METROPOLITAN GOVERNMENT OF NASHVILLE AND DAVIDSON COUNTY

STAFF RECOMMENDATION
3625 Richland Avenue
Lot 8, Richland Hall Development
November 20, 2019

Application: New Construction—Infill and Outbuilding; Setback Determination
District: Richland-West End Neighborhood Conservation Zoning Overlay
Council District: 24
Base Zoning: RS7.5
Map and Parcel Number: 104090297.00
Applicant: Chad Gore, Mike Ford Builders
Project Lead: Jenny Warren, jenny.warren@nashville.gov

Figure 1. Overall site plan for the 22 infill houses planned for the Richland-West End Neighborhood Conservation Zoning Overlay. The red box indicates the site currently under consideration.

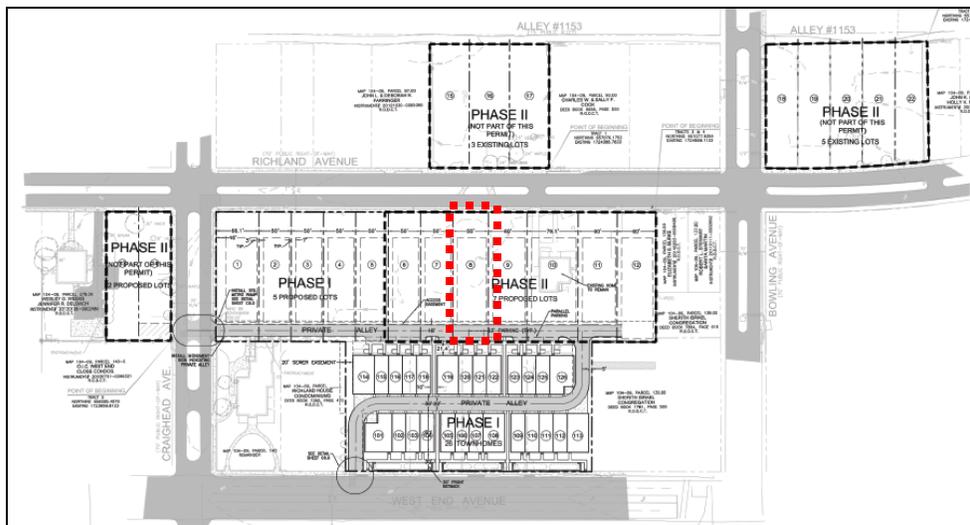
Background: 3625 Richland Avenue is a vacant lot that until recently was part of the Welch College (formerly the Free Will Baptist Bible College) campus. The College moved to a new location several years ago and in June 2015, the Metro Historic Zoning Commission approved a preliminary site plan for 22 new infill houses on the former campus, all located within the Richland-West Neighborhood Conservation Zoning Overlay (Figure 1). The Commission’s approval was contingent on the applicant returning to the Commission for approval of all infill design and site layout. To date, the MHZC has approved plans for nineteen of the twenty-two houses.

Figure 4. Side elevation

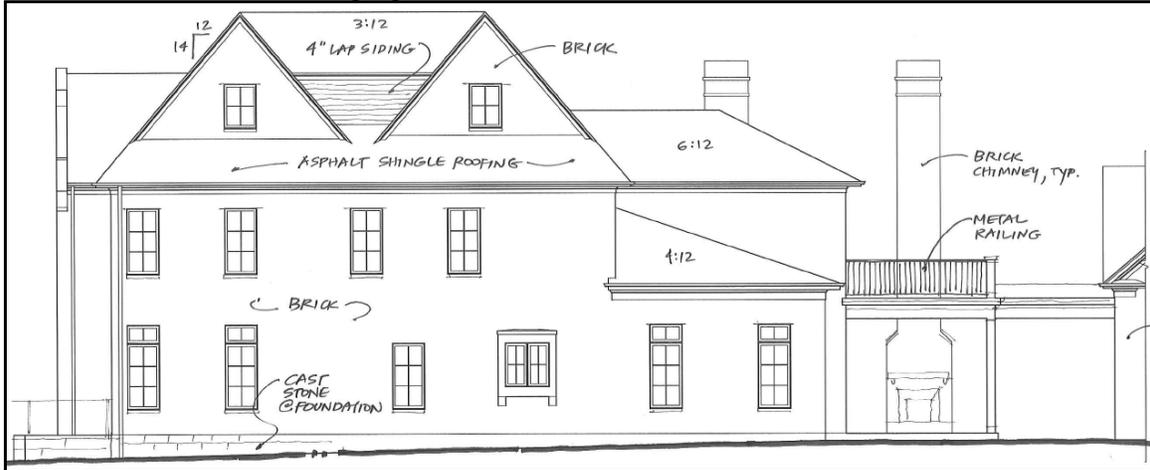
Proportion and Rhythm of Openings: The proposed windows on the infill are generally twice as tall as they are wide, thereby meeting the historic proportion of window openings. There are no large expanses of wall space without a window or door opening. All window groupings have a four to six-inch (4"-6") mullion in between the individual window openings. On the side elevations, there are a few nearly square windows. Staff finds these to be appropriate, because they are an accent, not the dominant window form, and because windows of this type are seen on historic examples. Staff finds that the infill's proportion and rhythm of openings meet Section II.B.1.g. of the design guidelines.

Figure 5. Outbuilding. Elevation facing the back of the house.

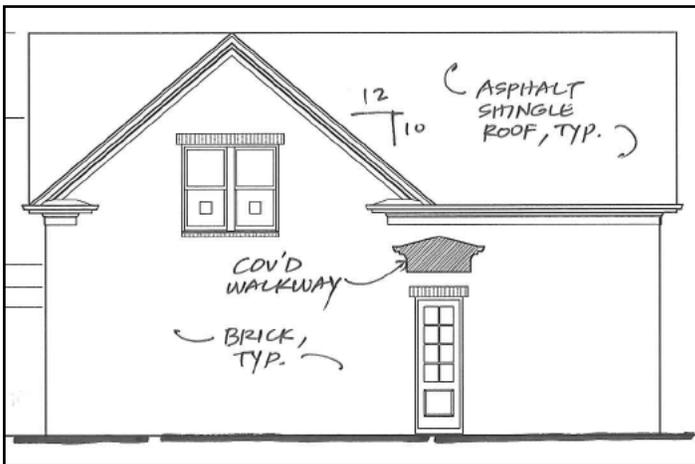
Outbuilding: The outbuilding will not contain a dwelling unit. This site is zoned for single family, and DADUs are not permitted under the current zoning.

The Commission typically requests to see at least twenty feet (20') between the primary structure and the outbuilding. The applicant is proposing just ten feet (10'9") between the structures. The Commission has approved the distance of ten feet (10') between the primary structures and the outbuildings for other lots on this block. The overall development is creating a new alley at the rear of these lots, using the rear thirty feet (30') of the lots for this purpose, and making the back portion of the lot unavailable for building. The outbuilding cannot be pushed any further to the rear because of this new alley; therefore, staff finds that the distance between the primary house and the outbuilding to be sufficient.

Base zoning requires that outbuildings larger than seven hundred square feet (700 sq. ft.) be located twenty feet (20') from the rear property line and five feet (5') from the side property lines. The outbuilding will be more than twenty feet (20') from the rear property line, although it will appear to be much closer because the rear portion of the lot will be dedicated to a new private alley. The outbuilding will meet the right side setback, but will require a side setback determination for the left side property line. It will be just three feet (3') from the property line on this side, rather than the required five feet (5'). Staff finds the proposed three-foot (3') side setback to be appropriate because it will line up with the setback of the proposed infill. In addition, historically, outbuildings were located close to or on the side property lines.

The proposed outbuilding will be constructed on an eleven thousand, fifty-five (11,055) square foot lot. On lots greater than ten-thousand (10,000) square feet, outbuildings can have a maximum square footage of up to 1,000 square feet. The proposed outbuilding meets this requirement with a footprint of about eight hundred and thirty-two (832) square feet.

With the final approval of all materials, staff finds that the proposed outbuilding meets Section II.B.1.h of the design guidelines.

C2
 SITE PLAN

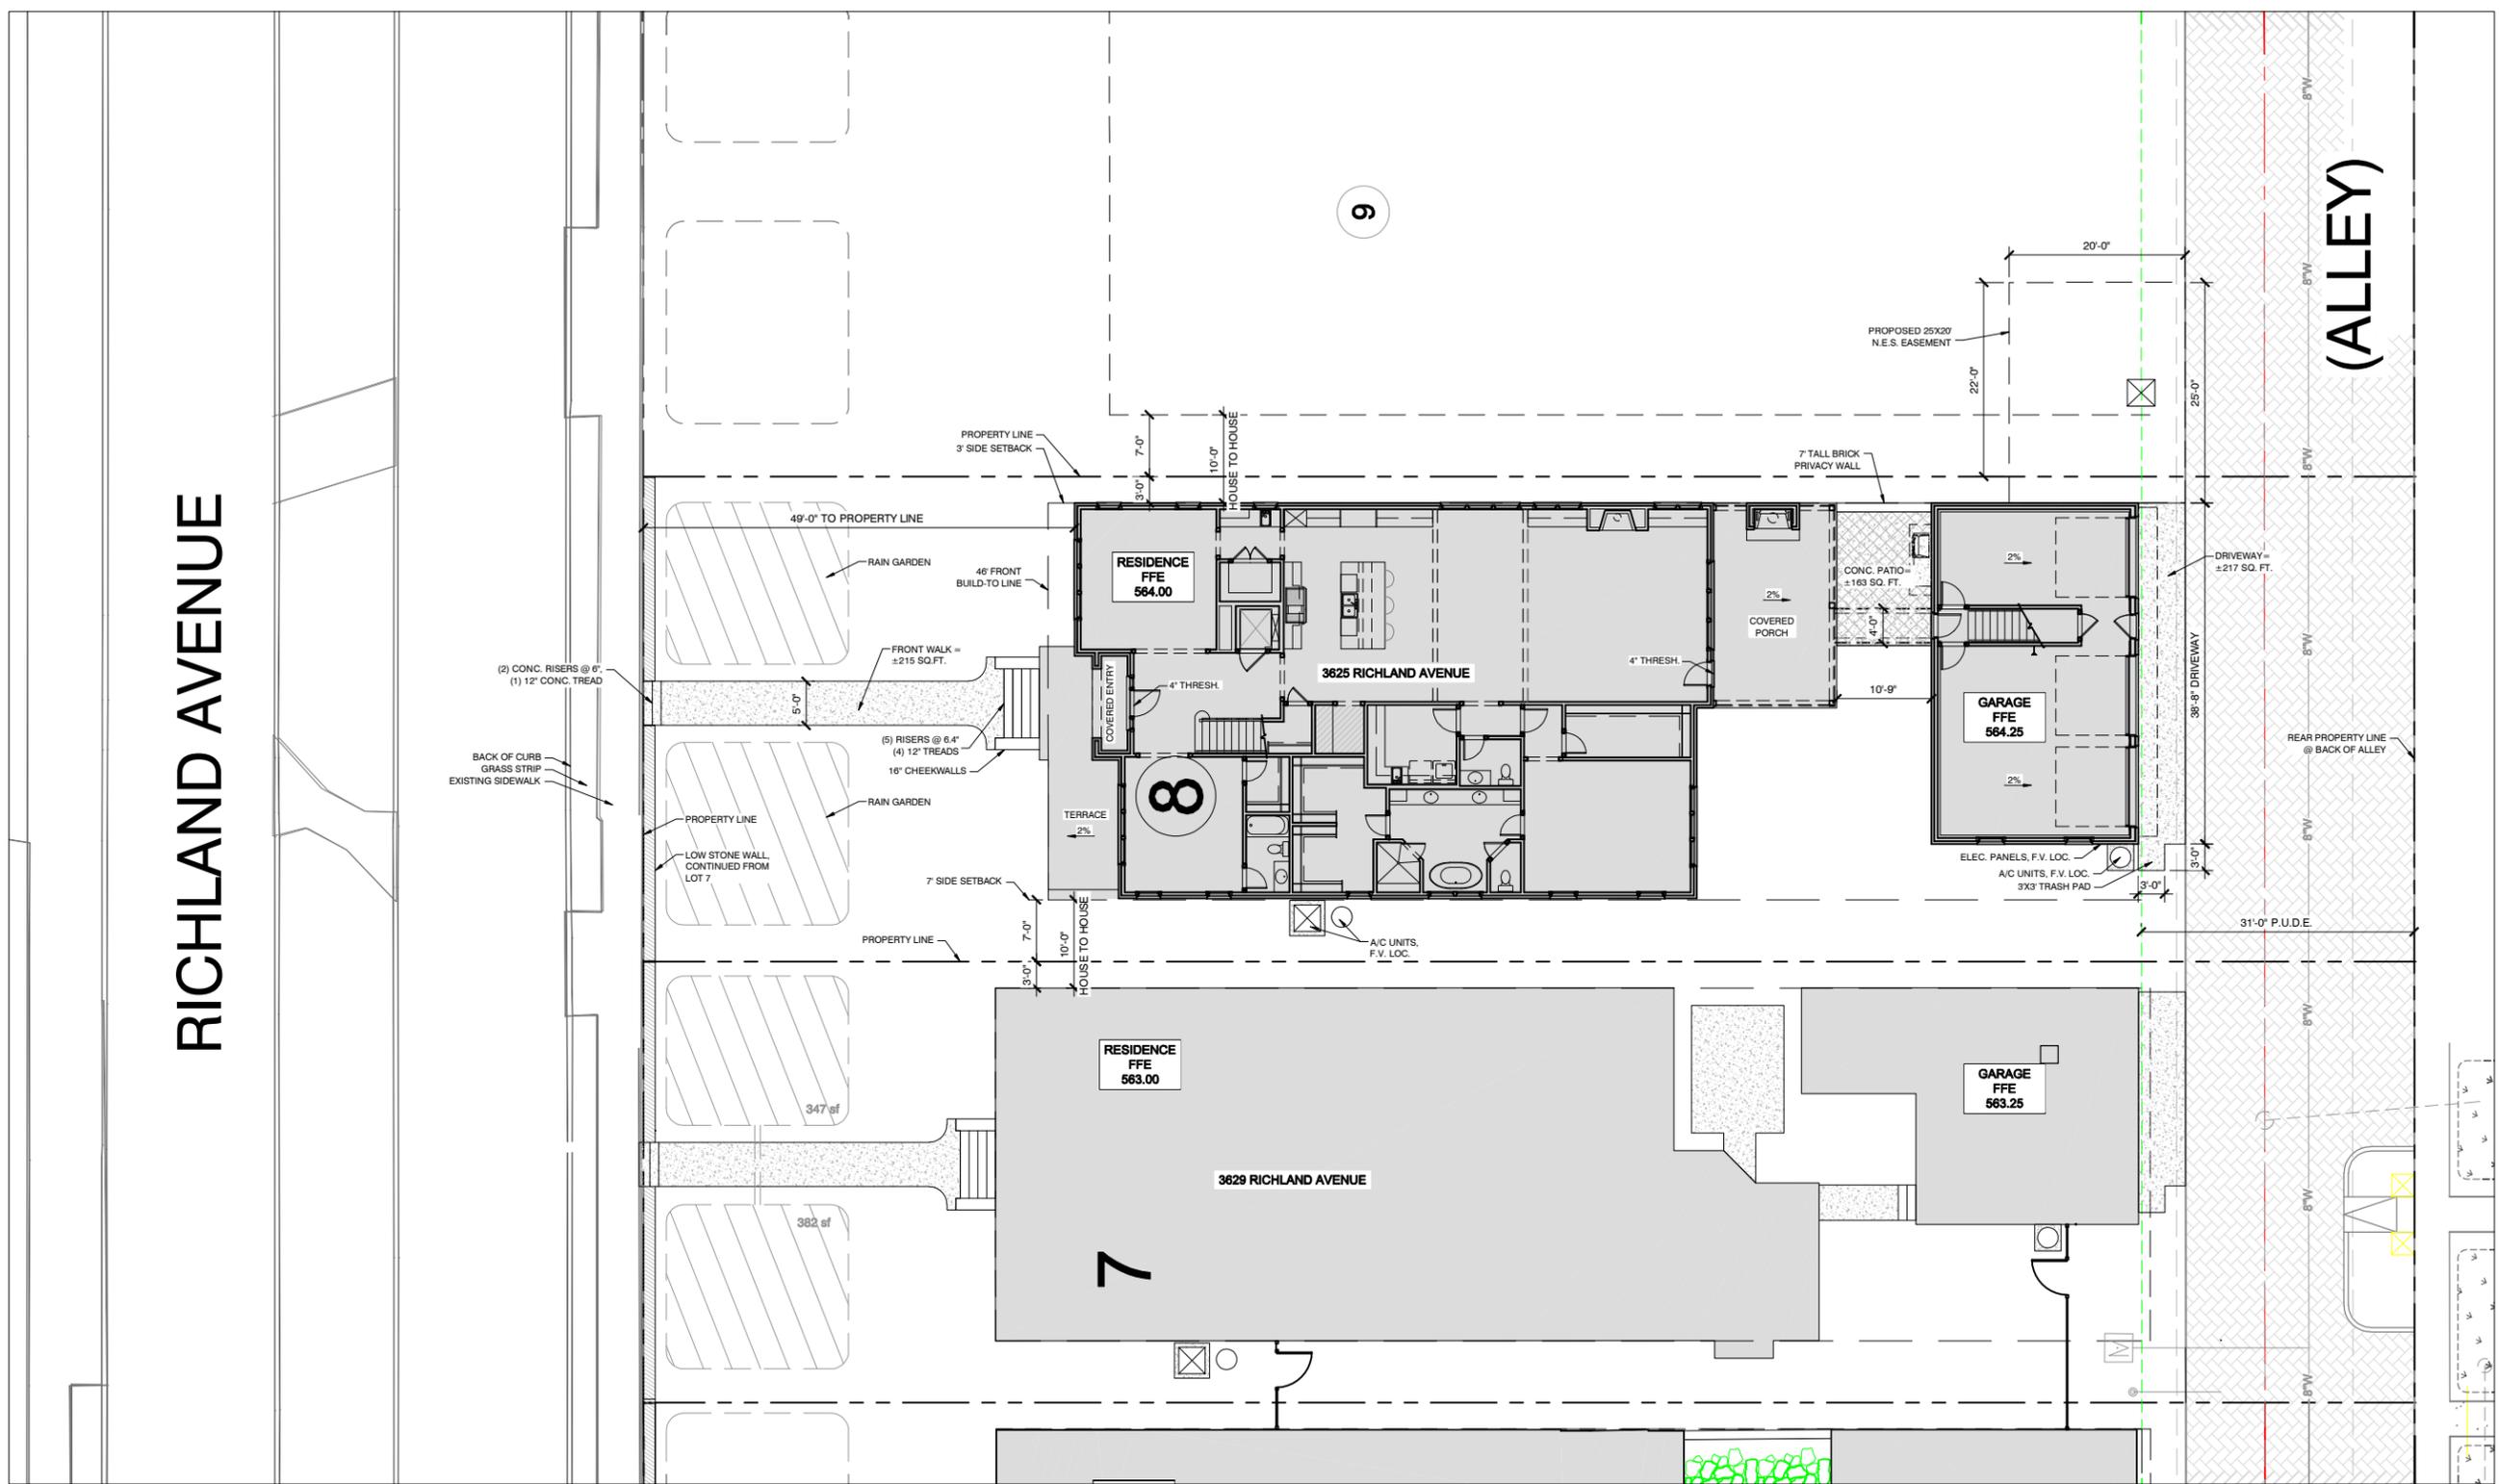
The proposed infill will have a front setback of forty-nine feet (49') to the front wall of the house. The seven infill houses to the right of this property (lots 1-7), all have a forty foot (40') front setback. This house will be set back slightly further to begin the transition to the historic house two doors down at 3617 Richland Avenue. This house is setback seventy feet (70') from the street. Staff finds that the proposed front setback meets the design guidelines and the historic context.

The right-side elevation will be seven feet (7') from the side property line, which meets the required base zoning setback of five feet (5'). On the left side, base zoning also requires a five-foot (5') side setback, but the applicant is proposing to set the infill just three feet (3') from the side property line. Staff finds this reduced side setback to be appropriate because there are other homes in the immediate vicinity that do not meet the required five-foot (5') side setback. In addition, the infill is part of a larger development, and the reduced setback will affect the parcel next door at 3621 Richland Avenue, which is also part of the development. Staff has yet to review the site plan for 3621 Richland Avenue, but has directed the applicant that the right side of 3621 needs to be set at least seven feet (7') from the side property line. This will ensure there is at least ten feet (10') in between nos. 3625 and 3621 Richland Avenue and that the reduced side setback will not affect overall rhythm of spacing on the street. The Commission has approved similar setback determinations elsewhere in the Welch College development.

The back of the house will be more than sixty feet (60') from the rear property line.

MINIMUM	PROPOSED
Building located towards rear of lot		Yes
Space between principal building and DADU/Garage	20'	10'9"
Rear setback	20'	30'+
L side setback	5'	3' (Requires setback determination)
R side setback	5'	~14'
How is the building accessed?		From new private alley
If the building is two-bay and the vehicular doors face the street, are there two different doors rather than one large door?		N/A

1 FRONT ELEVATION
1/4" = 1'-0"

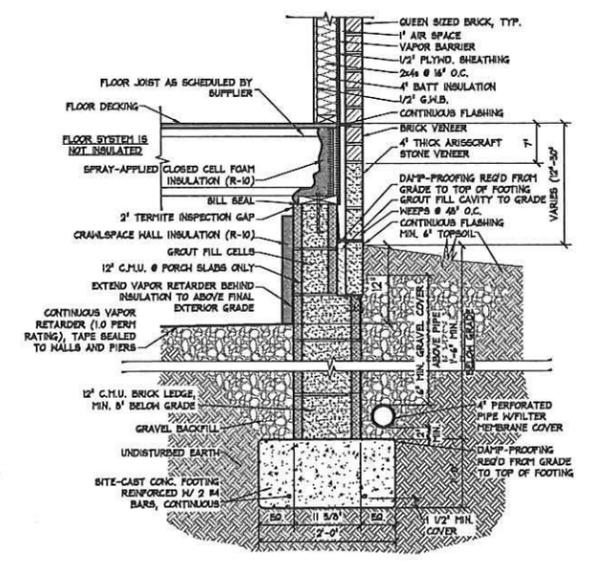
The proposed infill will be two stories, with a maximum height of thirty-nine feet (39') above the foundation at the front, and approximately forty-one feet (41') above grade. The house will have an eave height of approximately twenty-three feet, six inches (23'6") above the foundation at the front. The foundation height will vary due to grade, but will be approximately twenty-four inches (24") at the front. Staff finds

historic houses in the immediate vicinity, which range from thirty to forty-four feet (30' – 44'). It is also in keeping with what has been approved in the past for the infill houses in this development.

The lot is approximately fifty-five feet (55') wide. The house will be approximately forty-five feet wide (45') wide at the front. This width is similar to the widths of the historic houses in the immediate vicinity, which range from thirty-eight to sixty-five feet (38'-65') in width. The infill houses approved for Lots 2, 3, 4, 5, 6 and 7 of this development – to the right of the subject lot - are all narrower at approximately forty feet (40') wide. However, those houses all sit on fifty foot (50') wide lots. Staff finds that the proposed width is appropriate for this fifty-five foot (55') lot.

The height and scale of the proposed infill for Lot 8 is similar to the height and scale approved by MHZC for the other lots of this development. Staff recommends verification of the construction height of the foundation and floor systems in the field to ensure that the finished floor line of the new construction is compatible with the historic context. With this condition, staff finds that the height and scale meet Sections II.B.1.a. and II.B.1.b. of the design guidelines.

The infill’s primary roof form is side gabled, with a projecting front gable. The slope is 14/12. The decorative parapet at the front projecting gable is not typical of the district, but a similar form can be found a few blocks over at 117 Mockingbird Road, in the neighboring Cherokee Park Neighborhood Conservation Zoning Overlay (Figure 3). If this type of parapet were to be proposed for an infill site with flanking historic houses on both sides, it may not be appropriate. However, staff finds it to be appropriate in this instance, for this site, because the infill will be set among nine new adjacent infill houses. This development includes twenty-two (22) new houses all located on Richland Avenue. Allowing for a variation in design that maybe atypical of the district, but which can be found on an historic house nearby, will help diversify the development and distinguish the individual houses.

1. The finished floor height be consistent with the finished floor heights of neighboring historic houses, to be verified by MHZC staff in the field;
2. Staff approve the materials prior to purchase and installation, including: windows and doors, garage doors, brick, shingle color, porch materials and outbuilding awning material
